Drain: ALBERT SHAW ORAIN Drain #: 70
Improvement/Arm: CLAYBORNE-SECTION 4
Operator: JOH Date: 6-14-04
Drain Classification: Urban/Rural Year Installed: 2007

GIS Drain Input Checklist

Albert Shaw Drain - Claybourne Section 1

Re: Albert Shaw Drain: Clayborne Sec. 1 Arm

STORM SEWER PLAN
SUBSURFACE DRAIN LOCATIONS
DRAWING FILES:
R: \3K\3690\001\DWGS\C101XSRD

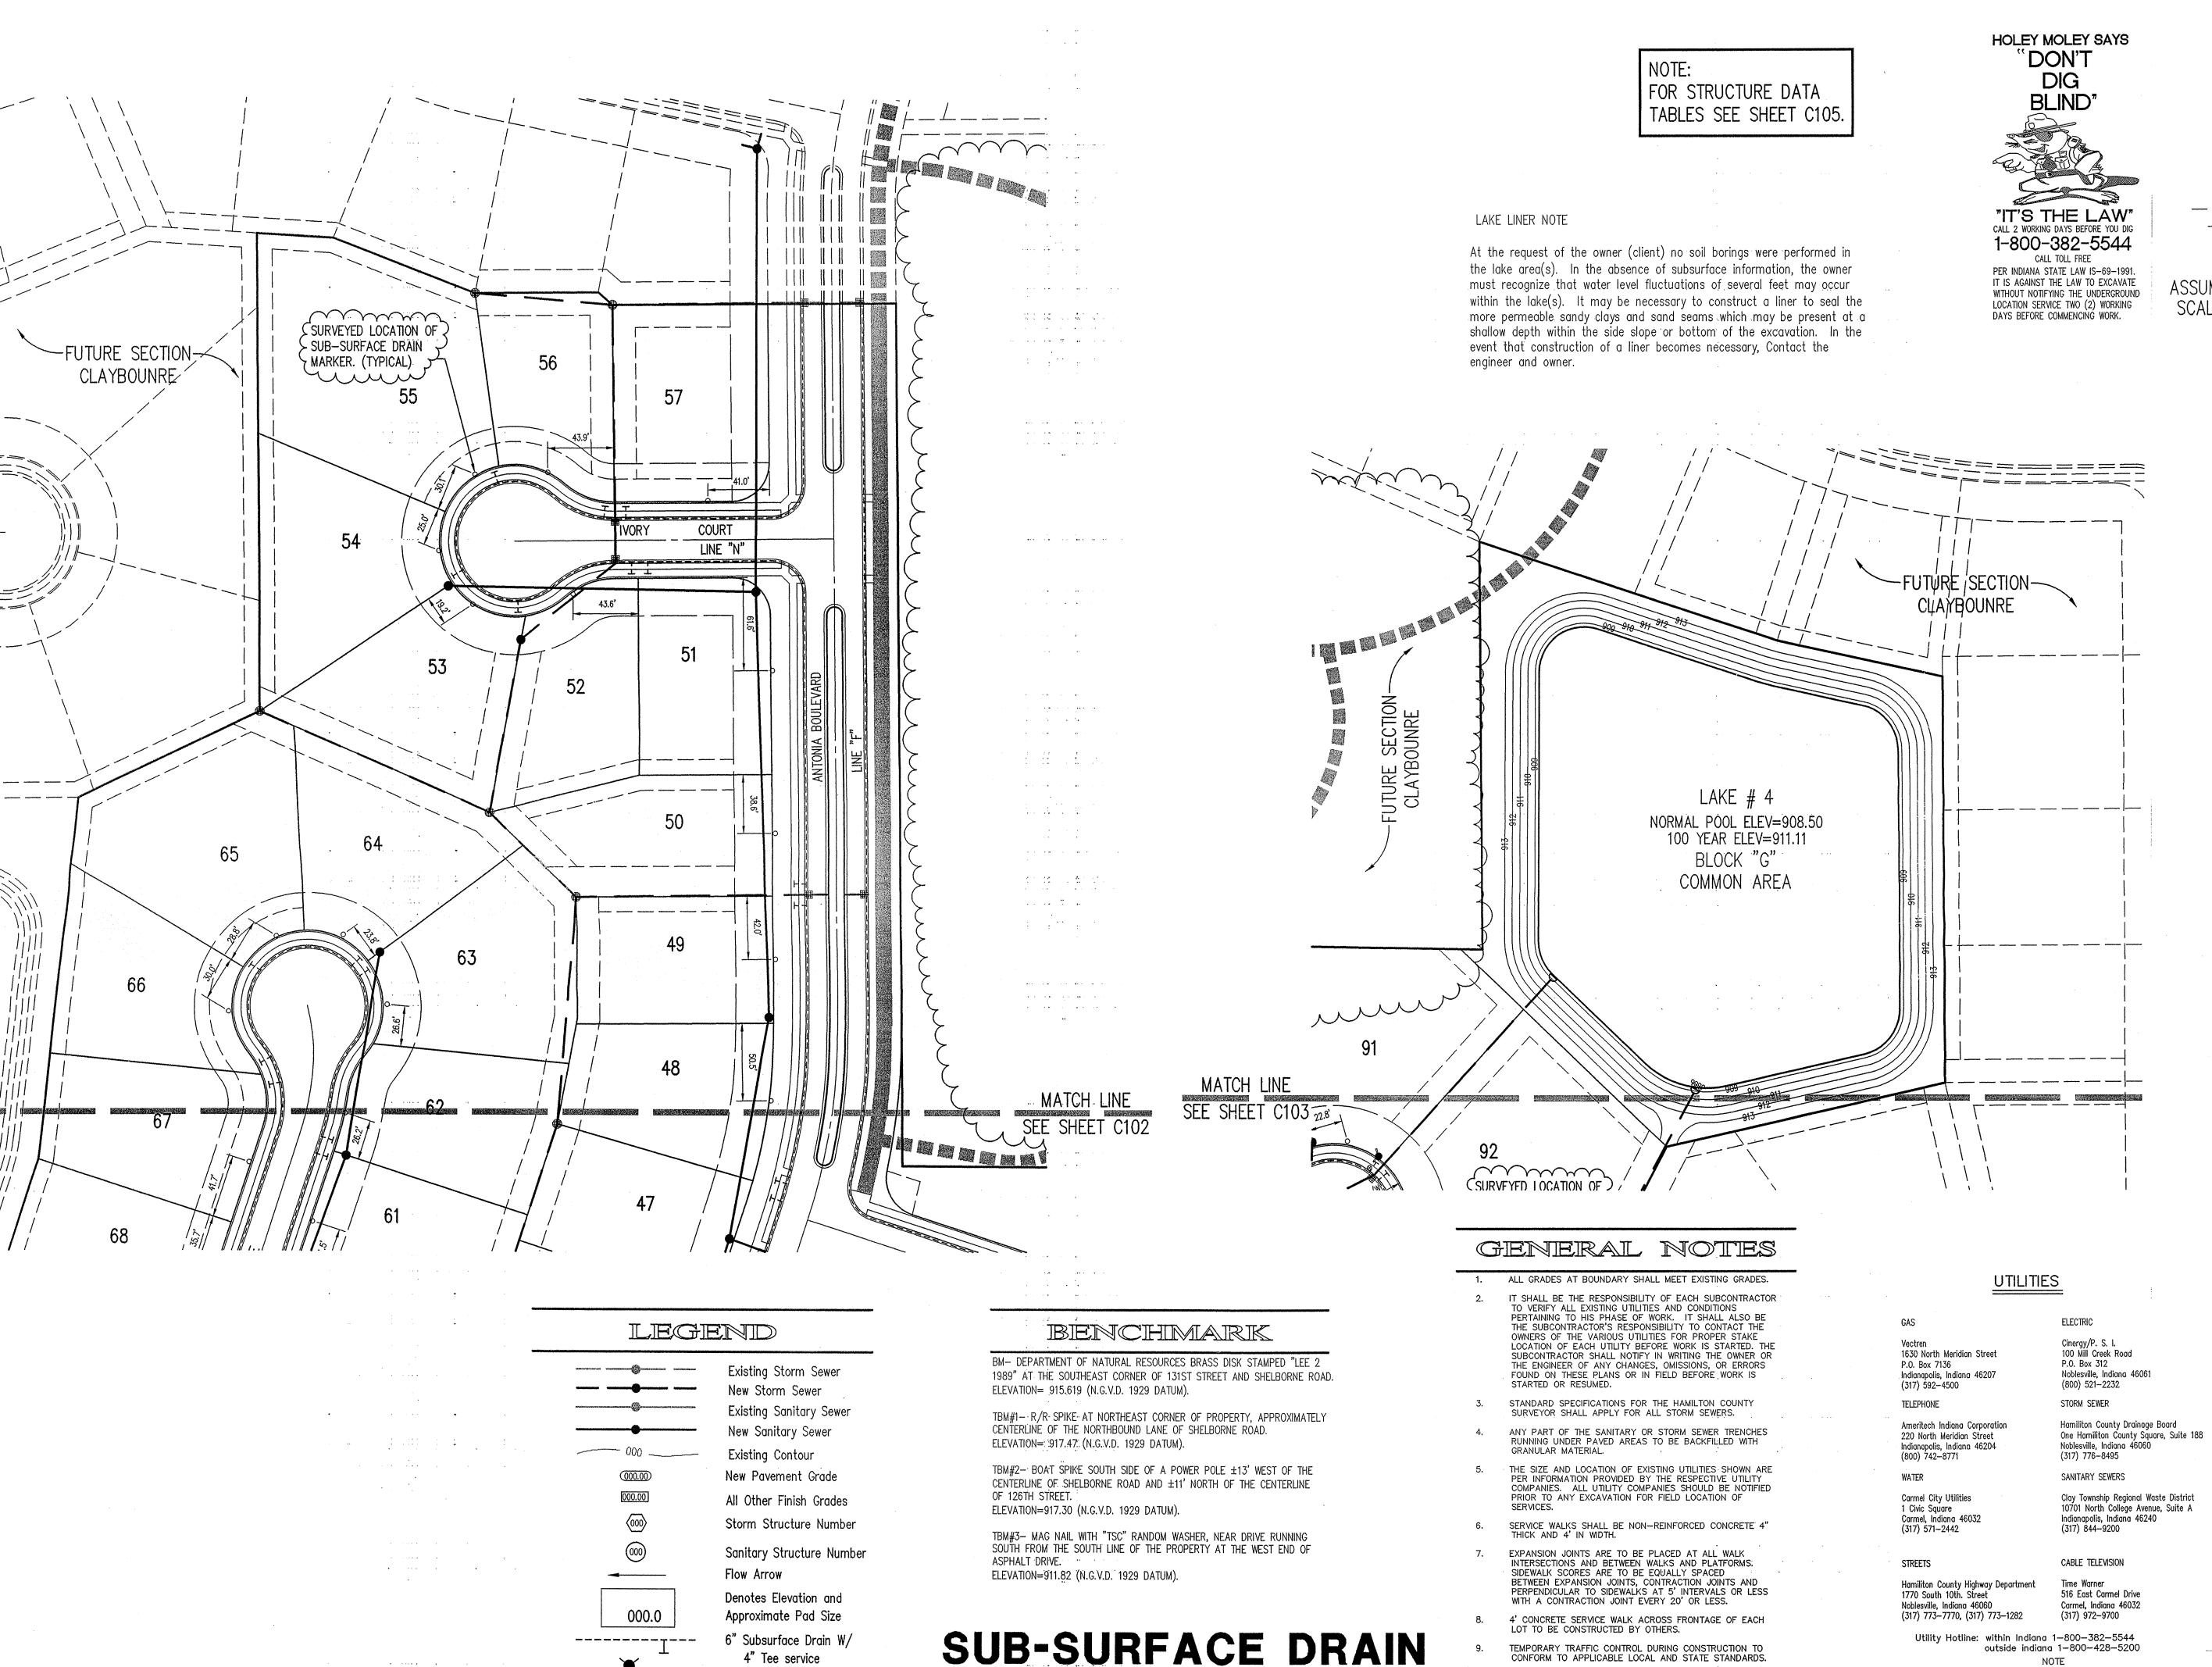
During construction, changes were made to the drain, which will alter the plans submitted with my report for this drain-dated July 3, 2002. The report was approved by the Board at the hearing held August 26, 2002. (See Drainage Board Minutes Book 6, Pages 419-420) The changes are as follows:

Structure:	T.C.:	I.E.:	Pipe:	Length:	Grade:	Original:	Difference:	
183	910.29	907.64						1
182	911.89	907.27	12	177	0.21	175	2	ıi,
161	912.51	910.37						1
160	912.66	909.44	12	136	0.68			٦,
160	912.66	909.44						1
159	912.73	909.13	12	30	1.03			1.
159	912.73	909.13						1
158	912.94	906.96	12	148	1.47	146	2	١,
165	913	911.08						1
164	915	910.29	12	53	1.49	54	-1	1
164	915	910.29						1
163	915.04	909.93	12	42	0.86			١,
163	915.04	909.93						1
162	913.24	908.02	12	157	1.22			1
178	913.77	911.53						1
175	914.13	910.99	12	93	0.58	92	1	1.
177	915.76	912.83						1
176	915.9	912.38	12	42	1.07			1,
176	915.9	912.38						1
175	914.13	911.22	12	123	0.94	125	-2	1 .
175	914.13	910.34						1
174	915.6	910.26	12	141	0.48	140	1	1

174	915.6	910.26	1	ı			I
	173	915.55	910	12	30	0.87	 	
	173	915.55	910	12	- 30	0.07	+	
	172	917.82	909.64	15	83	0.31	81	2
	172	917.82	909.64	10		0.51	01	
	170	914	909.04	15	116	0.52		
	170	914	908.99		110	0.02	1	
	167	914.75	908.45	18	78	0.69	80	-2
	167	914.75	908.45			0.00	00	
	166	914.48	907.44	18	148	0.68	149	-1
	166	914.48	907.44			0.00		_ •
	162	913.24	907.02	24	239	0.18		
	162	913.24	907.02			37.5		
	158	912.94	906.68	24	68	0.5	69	-1
	158	912.94	906.68			<u> </u>		· · · · · · · · · · · · · · · · · · ·
	157	912.57	906.29	24	132	30	131	1
	157	912.57	906.29					
	156	912.54	906.16	24	30	0.43		
	156	912.54	906.16					
	155		905.84	24	48	0.67	52	-4
	171	914.09	911.35				32	<u> </u>
	170	914	909.27	12	167	1.25	166	1
	169	915.16	911.84					
	168	915.13	911.61	12	42	0.55		
	168	915.13	911.61					
	167	914.75	908.58	12	152	1.99		
	194	914	911.38					
	193	914.93	909.28	12	122	1.72	119	3
	201	914.08	910.84					
	200	914.09	910.49	12	30	1.17

200	914.09	910.49					
	199	914.08	909.36	12	142	0.8		
	204	914.61	911.44					
	203	914.58	911.17	12	30	0.9		
	203	914.58	911.17					
	202	914.31	910.35	12	158	0.52	159	-1
B" SSD Street	s:						RCP Pipe To	otals:
Antonia		1109.67					12	2,015
-eetan		565.5					15	199
Haskell		731.81					18	226
Kegler		791.64					24	517
Teague		490.3				,	Total:	2,957
_anana		530.58						•
	x2

The length of the drain due to the changes described above is now 11,396 feet.
